SERVICE BULLETIN

TS-660

#856

SUBJECT: TS-660 Microprocessor Latchup

On the Control unit X53-1220-00:

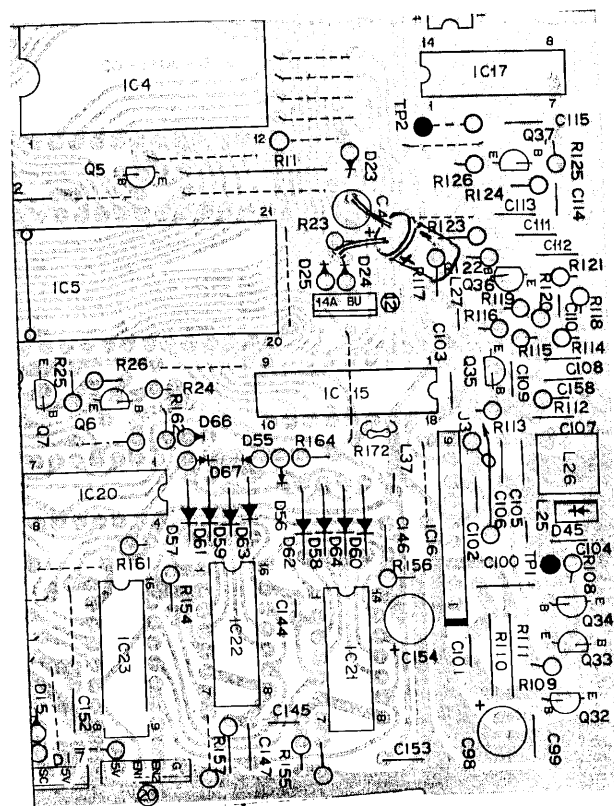
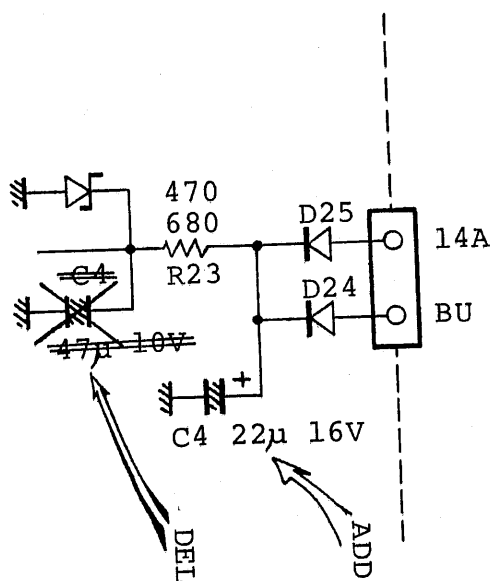
Microprocessor latchup may occur if the power switch is cycled several times in quick succession, if the supply is turned off while the power switch remains on, or if the power supply is turned on with the transceiver already on. Symptom will be no display, erroneous display, or locked display. Change two components on the Control unit to prevent further trouble.

1. Replace R23 680 Ω with a 470 Ω resistor (RD14CB2E471J).
2. Remove and delete C4 47 μ F
3. Add a 22 μ F 16V electrolytic (CE04W1C220M) on the foil side of the board between D24, R23 (positive) and ground (negative).
